Centuria Capital Limited
Warehouse and Office

88 Newton Road, Wetherill
Park NSW

Access Review

18 April 2024

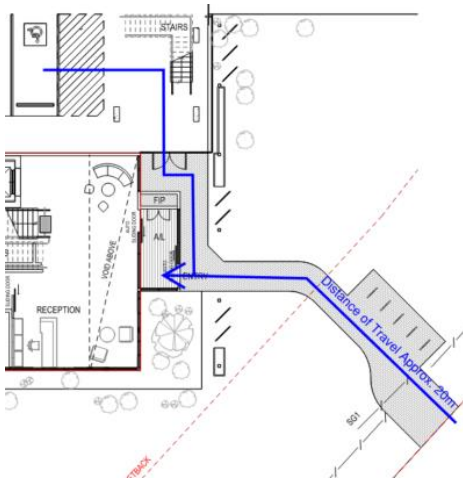
MGAC has reviewed the drawings and documentation in relation to the aforementioned requirements. An accessible path of travel is evident in the drawings from the site boundary to the building entrance on the ground floor and from the accessible parking spaces noted.

Based on the current level of detail all access requirements appear capable of achieving compliance. Further work will be required during design development stage to ensure appropriate outcomes are achieved.

Ground Floor External Linkage

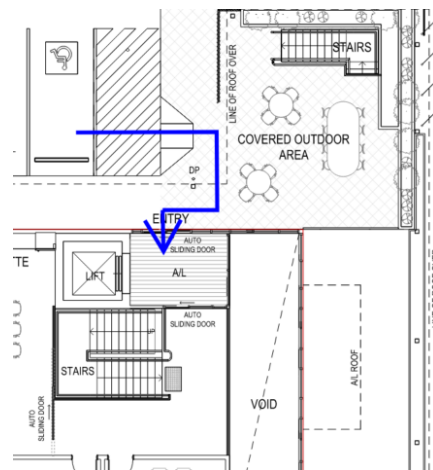
MGAC has reviewed the drawings and documentation in relation to the aforementioned requirements. The Main entrance on the ground floor is located adjacent to the accessible parking provided on that level and provides entry to the main lobby area. The level one entry is located adjacent to the accessible parking provided on that level. Both have direct access to the passenger lift.

Based on the current level of detail all access requirements appear capable of achieving compliance. Further work will be required during design development stage to ensure appropriate outcomes are achieved.
